Subject: Duke Energy Carolinas, LLC  
William States Lee III Nuclear Station – Docket Nos. 52-018 and 52-019  
AP1000 Combined License Application for the  
William States Lee III Nuclear Station Units 1 and 2  
Supplemental Response to Request for Additional Information  
Ltr# WLG2012.04-08

**Lee Nuclear Station Response to Request for Additional Information (RAI)**

**Reference NRC RAI Number: ER RAI 190 Supplement, Site Layout and Plant Description**

**Reference NRC RAI Number: ER RAI 210 Supplement, Ecology - Aquatic**

Updated ER Figure 5.3-5,  
Make-Up Pond C Intake Structure  
Sheets 1 through 7 of 7

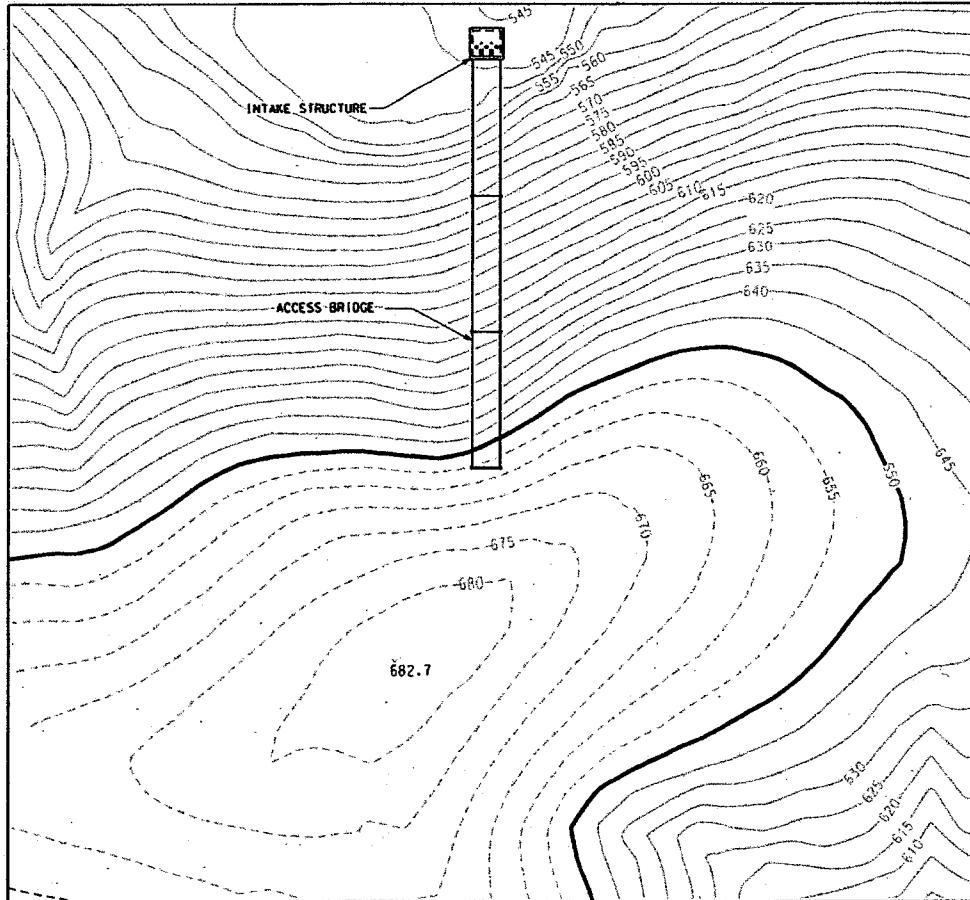
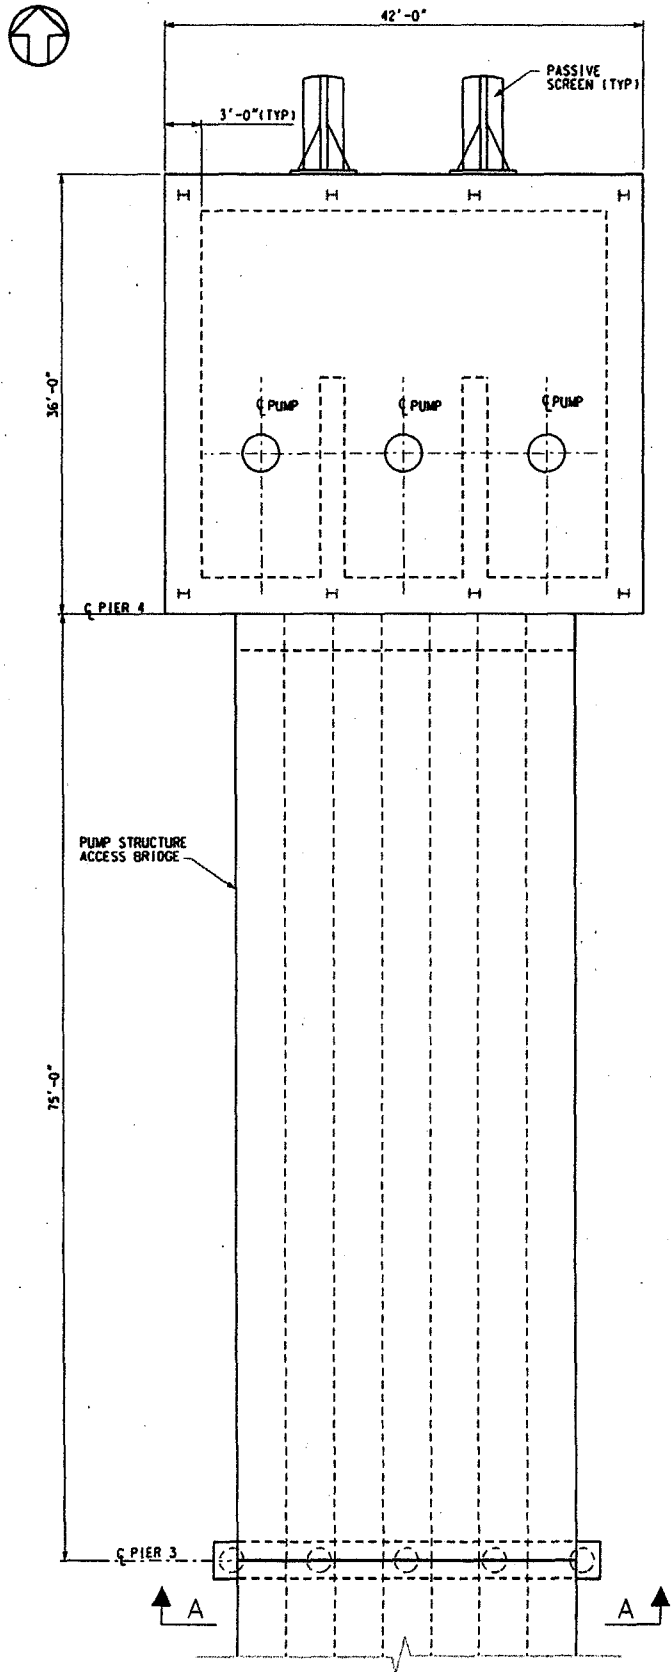
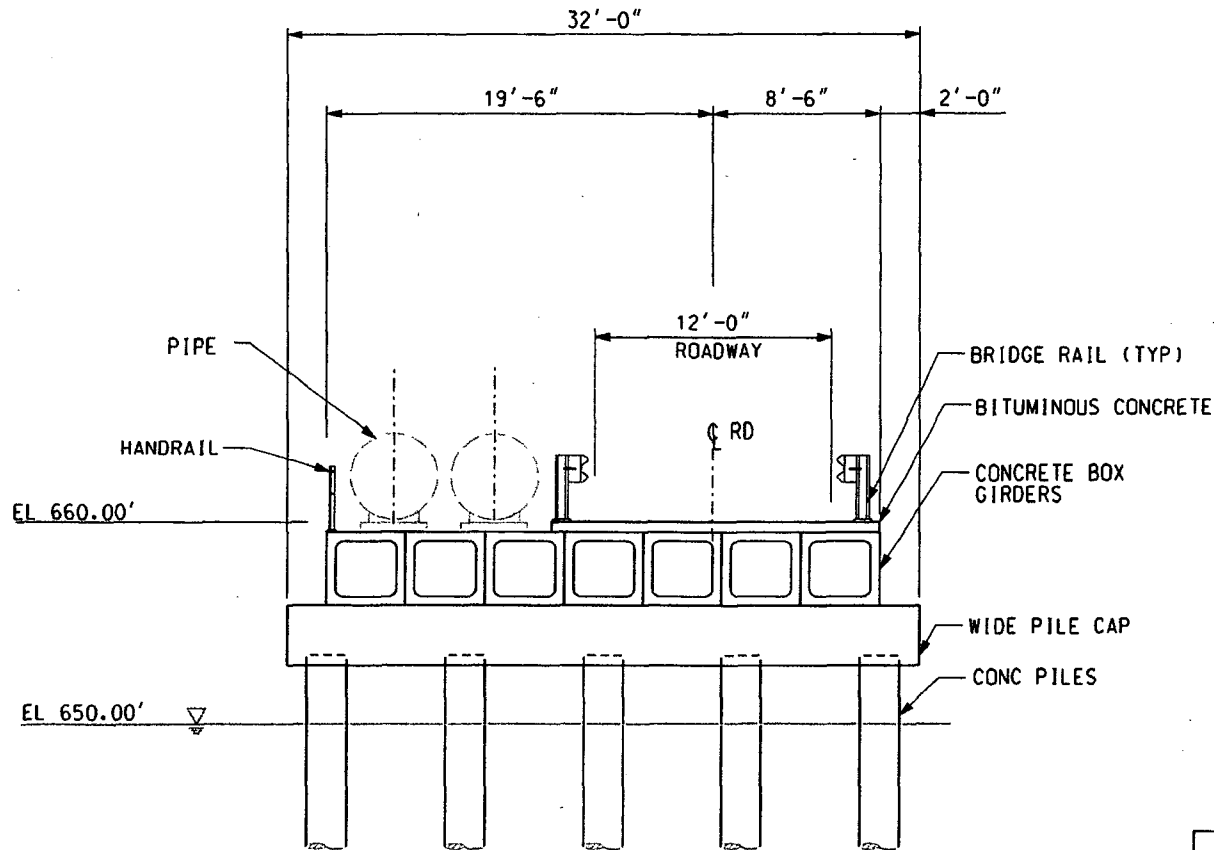
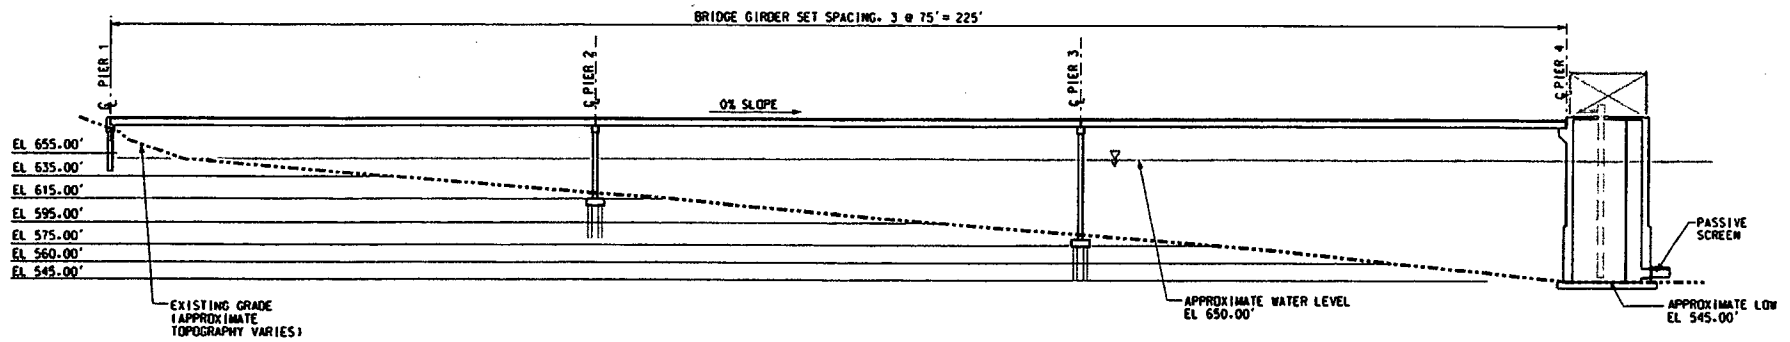
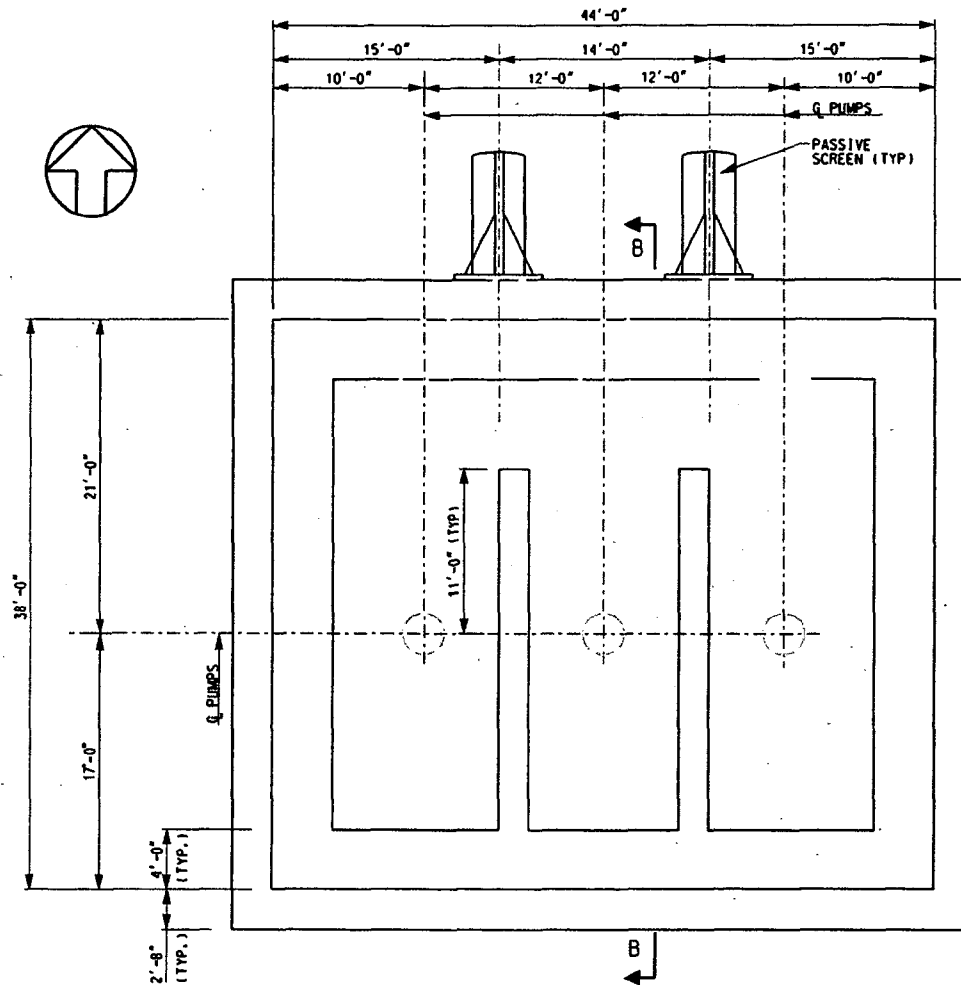
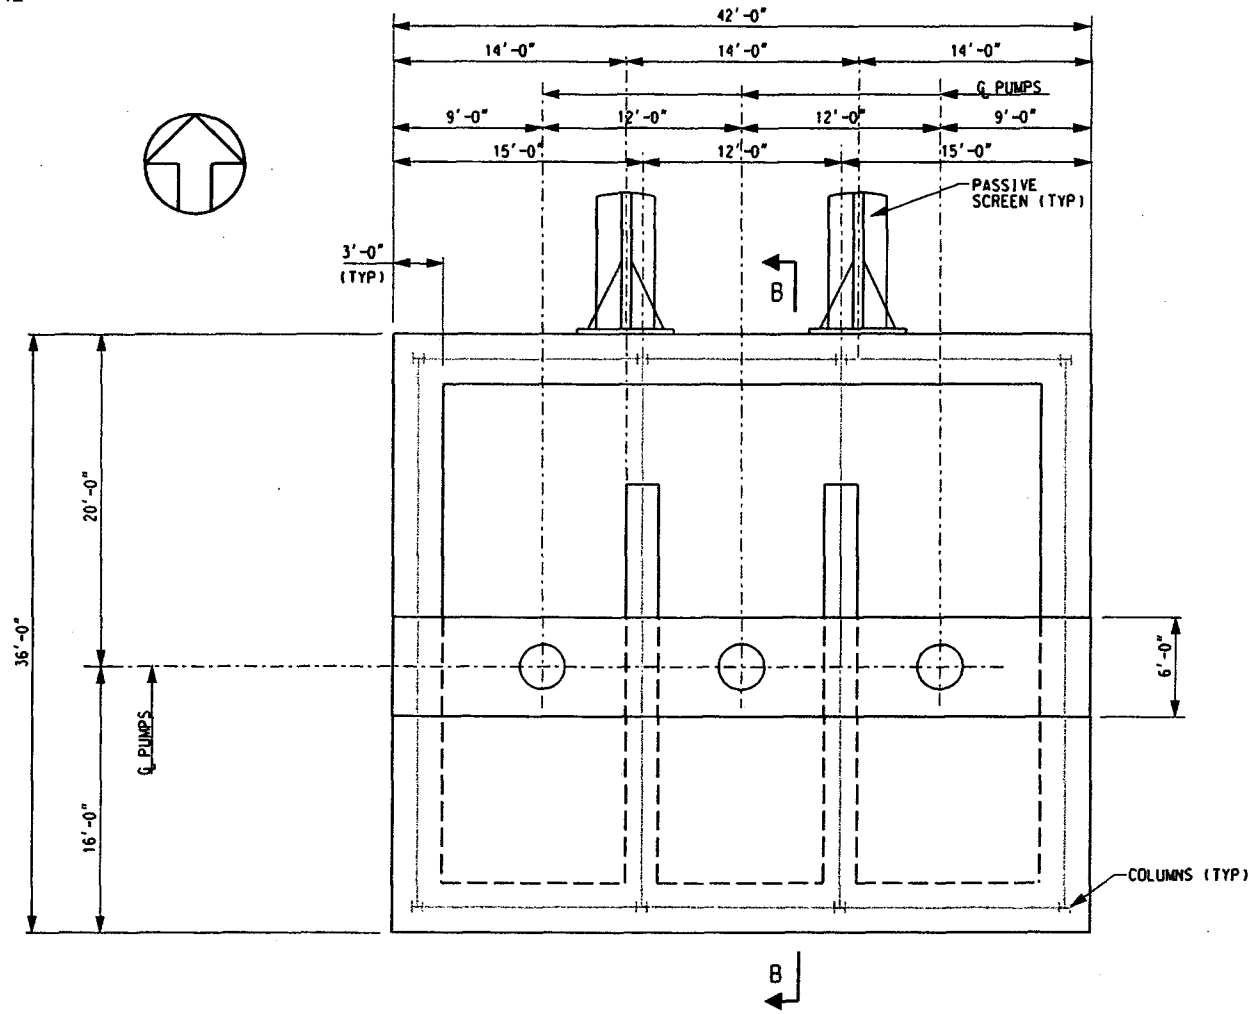
Provide bathymetric maps of Ponds A, B, and C that show clearly labeled contour lines with the locations of the intake screen and supporting structures superimposed. Provide plan and section views of each intake structure. For clarity and legibility, print the maps in black and white. Describe what is known about the options for wedge wire slot sizes for the traveling screens, particularly if an estimate or range of potential slot sizes is known. Provide information about the height the Pond B and C drum screens will be elevated above the substrate. Also, describe the potential cleaning methods for the Ponds A, B, and C intake screens. Indicate in the response when and how through-screen velocity calculations will be provided to the NRC (e.g., through submittal of a copy of the National Pollution Discharge Elimination System permit application).

The plan and section views of the Make-Up Pond B and Make-Up Pond C Intake Structures have each been shown on a separate sheet to enhance legibility of the intake structure drawings, ER Figures 5.3-2 and 5.3-5 respectively (Attachments 210S-02 and 210S-03). Additional details of the Passive Wedge Wire Cylindrical Drum Screens have been added to the plan and section views of the Make-Up Pond B Intake Structure as reflected on ER Figure 5.3-2 (Attachment 210S-02). Likewise, additional details of the Passive Wedge Wire Cylindrical Drum Screens have been added to the plan and section views of the Make-Up Pond C Intake Structure as reflected on ER Figure 5.3-5 (Attachment 210S-03).
